**PLANNED UNIT DEVELOPMENT
STAFF REPORT****Date: March 1, 2007****DEVELOPMENT NAME** Clearbrook, LLC**LOCATION** 4071 Halls Mill Road, 1521 and 1525 Azalea Road
(East side of Azalea Road, 300'± South of Halls Mill Road.)**CITY COUNCIL
DISTRICT** Council District 4**PRESENT ZONING** I-1, Light Industrial**AREA OF PROPERTY** 11.37± Acres**CONTEMPLATED USE** Planned Unit Development Approval to allow an office building, light manufacturing building, equipment storage, vehicle storage, guard house, and model unit displays on a single building site, to be developed in phases.**TIME SCHEDULE
FOR DEVELOPMENT** In Phases, no time schedule provided**ENGINEERING
COMMENTS** Must comply with all storm water and flood control ordinances. Any work performed in the right of way will require a right of way permit.**TRAFFIC ENGINEERING
COMMENTS** Driveway number, size, location, and design to be approved by Traffic Engineering and conform to AASHTO standards.**URBAN FORESTRY

SITE PLAN

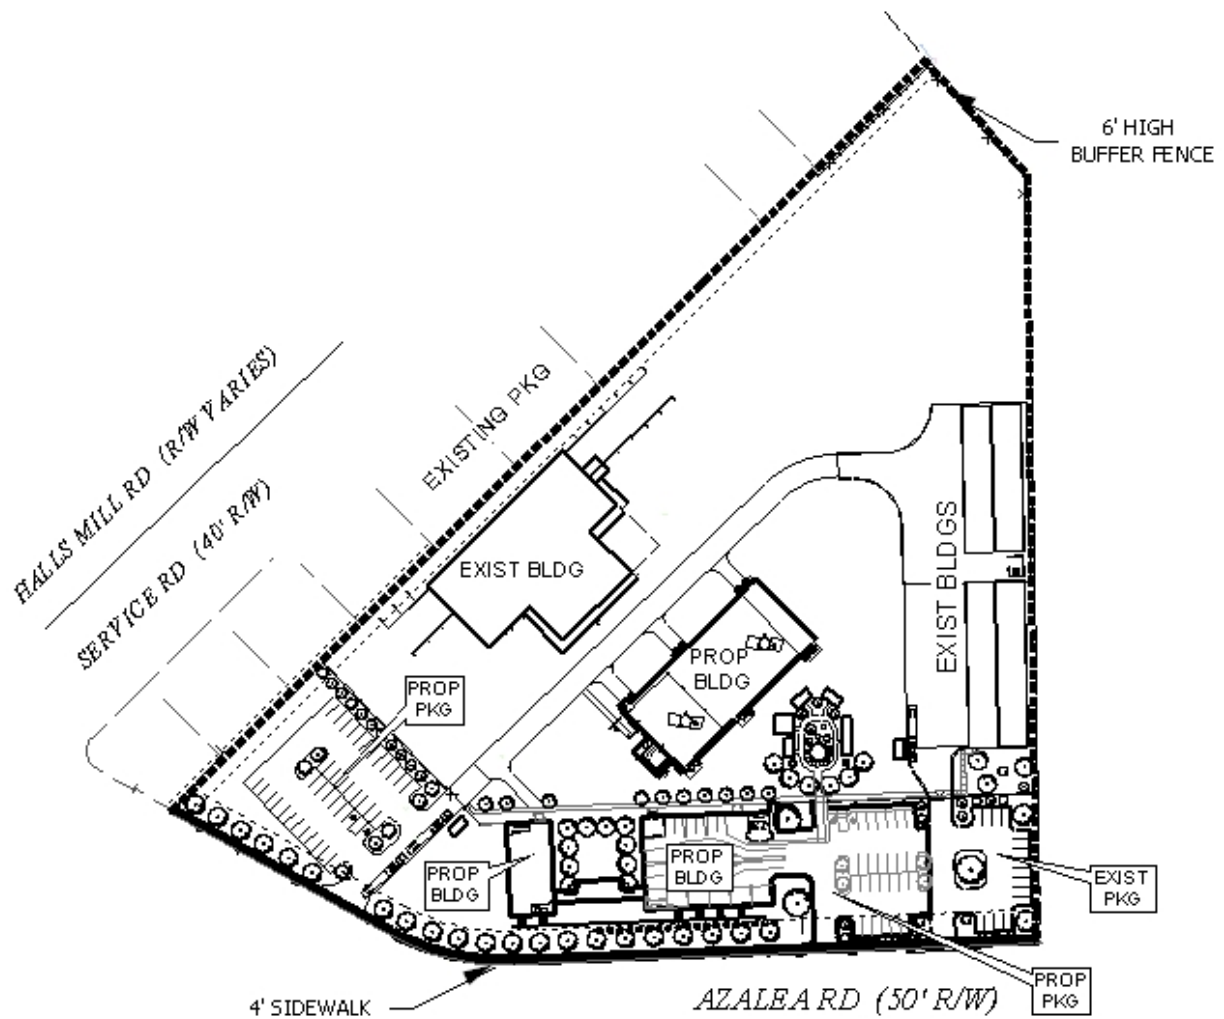
As PUD approval is site plan specific, it is imperative that adequate information be provided on the site plan and in the narrative description of the development. In this particular instance, neither the site plan nor the narrative provides adequate information regarding the proposed development for consideration for anything more than conceptual review of the proposed master plan. There is no information regarding building sizes was provided (square footage is needed for parking calculations); no information is provided regarding numbers of employees for the warehousing/light manufacturing buildings (also needed for parking calculations); no dimensions are shown for parking stalls, aisles, drives or internal circulation road for tractor trailers; a dumpster location is not shown; a buffer fence is shown, but is not adjacent to all residentially zoned property; and existing curb cuts that are not to be used are not noted as being removed.

While the proposed development will be a significant improvement to the site and the general area, the information submitted is simply incomplete and inadequate for review.

1. Provide information regarding building sizes (square footage is needed for parking calculations);
2. Provide numbers of employees for the warehousing/light manufacturing buildings (also needed for parking calculations);
3. Provide dimensions for buildings, parking stalls, aisles, drives and internal circulation road for tractor trailers;
4. Illustrate dumpster location, access and screening on site plan;
5. Illustrate buffer fence adjacent to all residentially zoned property; and
6. Illustrate existing curb cuts that are not to be used as being removed

Information and revised plans must be submitted by March 16.
